## ***Interactive comment on “Hydrometeorological analysis and forecasting of a 3-day flash-flood-triggering desert rainstorm” by Yair Rinat et al.***

Lorenzo Marchi, referee #2

Fig. 1. The corrected Fig 1 in the manuscript

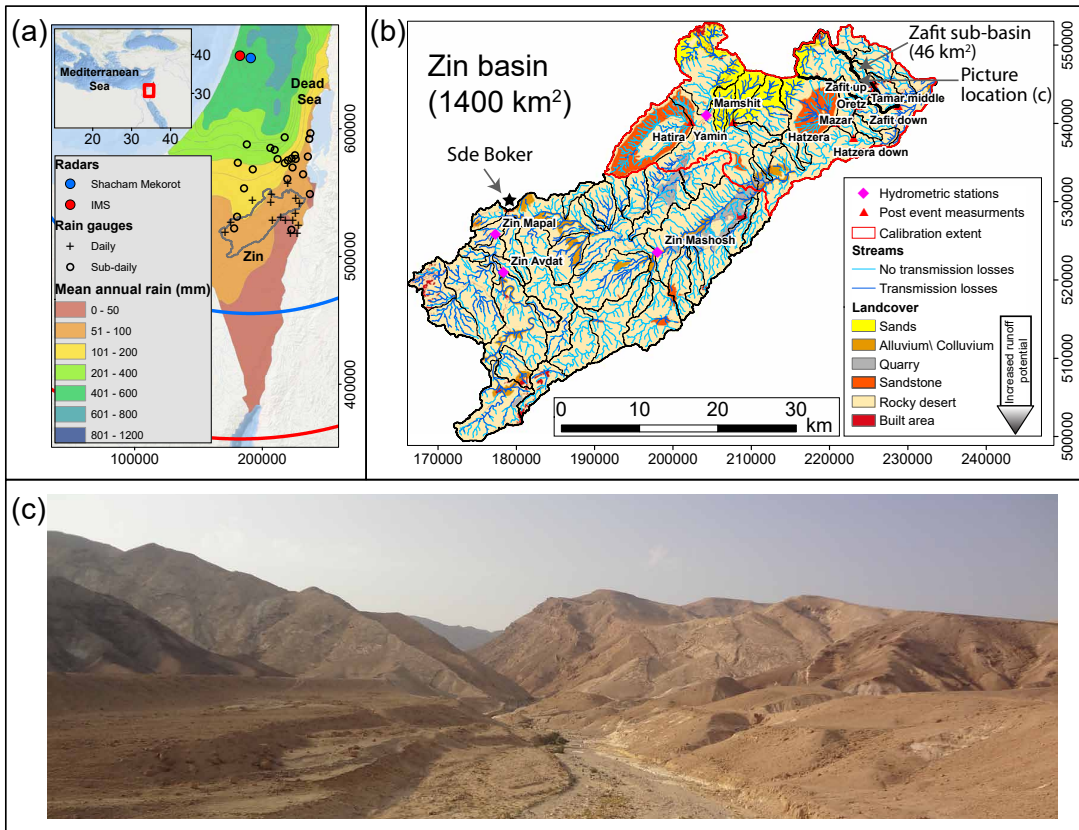
- Lines 136-137. The absence of rain gauges within the basin (cf. Fig. 1 and lines 169-170) should be clearly stated. Authors' answer: Thank you. The locations of all rain gauges were added to Fig1a as suggested, and a sentence was added for clarification: "Two rain gauges with temporal resolution of 10-min and eight rain gauges that provide only daily data monitor the basin"

- Lines 140-141. "however, only one of these monitors the area influenced by the storm's core": which one (cf. table 2)? Authors' answer: Corrected, the sentence has been changed to "however, only the Mamshit hydrometric station is situated at the area influenced by the storm's core (Fig 1b, Table 1)"

Fig. 2. The corrected Fig 5 in the manuscript

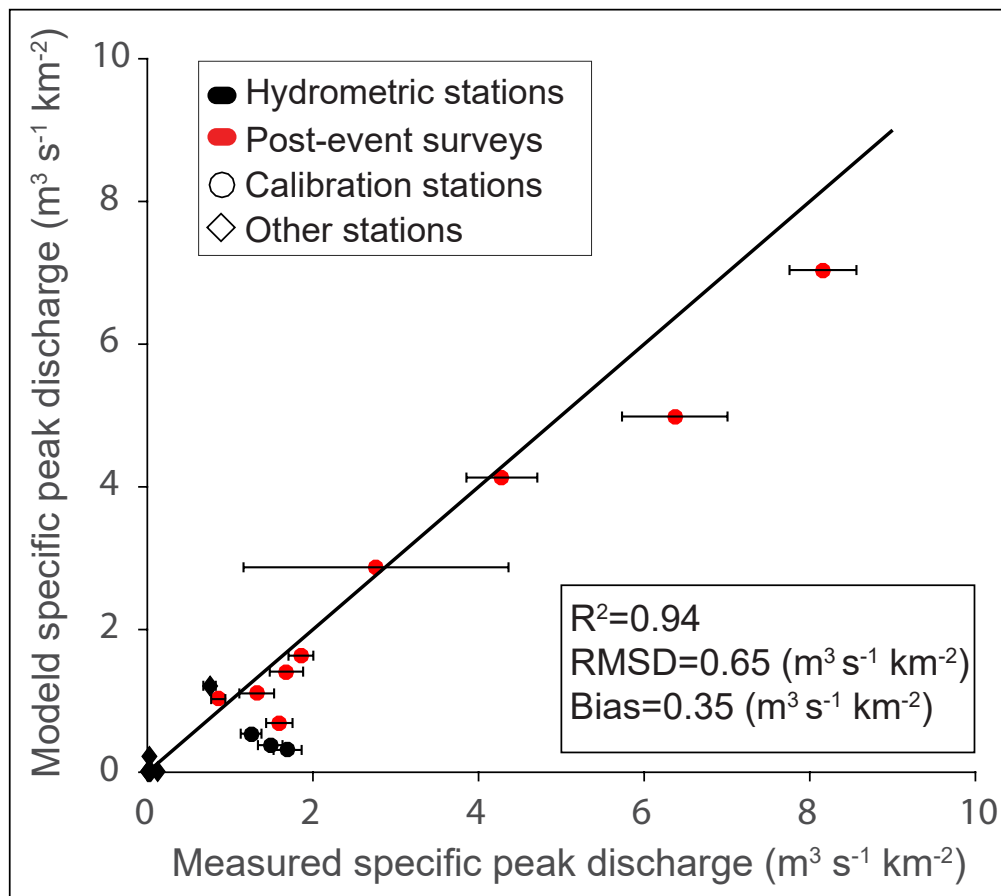
- The post-flood reconstruction of peak discharge is affected by several sources of errors, including measurement errors and uncertainties in the estimation of the roughness coefficient. The authors could consider assessing and presenting (Table 2 and

Fig. 5) the uncertainties bounds of post-flood peak discharge estimates. Indirect estimates of flash flood peak discharge, especially if validated by a rainfall-runoff model, like in this work, are of utmost importance for getting a better knowledge of these hazardous phenomena, also for comparison with other datasets. Reporting the uncertainties bounds increases the value of such flood peak data. Authors' answer: Uncertainty limits were added to Table 1 (previously Table 2) and Fig. 5 as suggested. Table 1 now contains 2 new columns: "Lower uncertainty limit" and "Upper uncertainty limit". Three types of data sets were used for all measured peak discharges: Type 1: six post event peak discharge estimates were derived by our team. For calculating the flood peak discharge, we surveyed post event high water marks such as drift wood and banks erosion lines. Topographic surveys of each of these reaches included the geometry of several cross-sections, longitudinal channel profiles and precise elevation measurements of the water marks. Discharge estimates were calculated by hydraulic modeling of the surveyed study reaches using HEC-RAS software. The uncertainties range of these estimations is now presented in the table. Type 2: three post event peak discharge estimates were derived by the Israel Hydrological Service and by the Soil and Erosion Research Station – both teams assess the uncertainty to be  $\sim 10\%$ . Type 3: ten peak discharge estimates were obtained from hydrographs produced by the Israel Hydrological Service from hydrometric station data. Uncertainty is also estimated here as 10%.
